# City of Mississauga Department Comments

Date Finalized: 2022-02-02 File(s): A44.22

The applicant requests the Committee to approve a minor variance to allow the existing walkways with:

Property Address: 1583 Watersedge Road

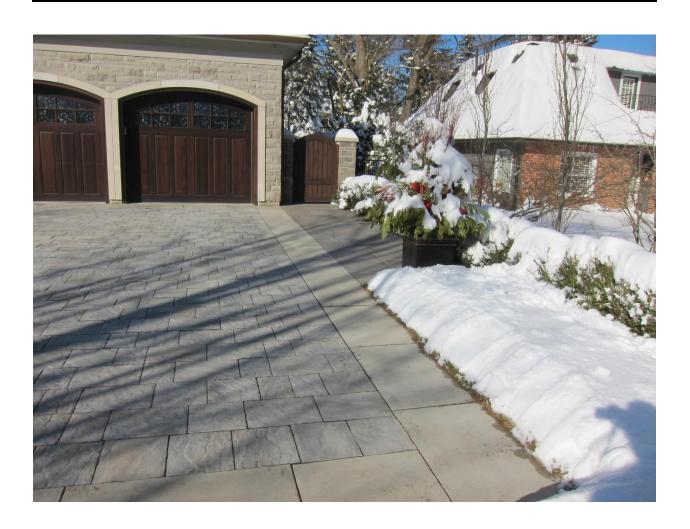
Enclosed for Committees information are photos depicting the existing walkways and driveway on the subject property.
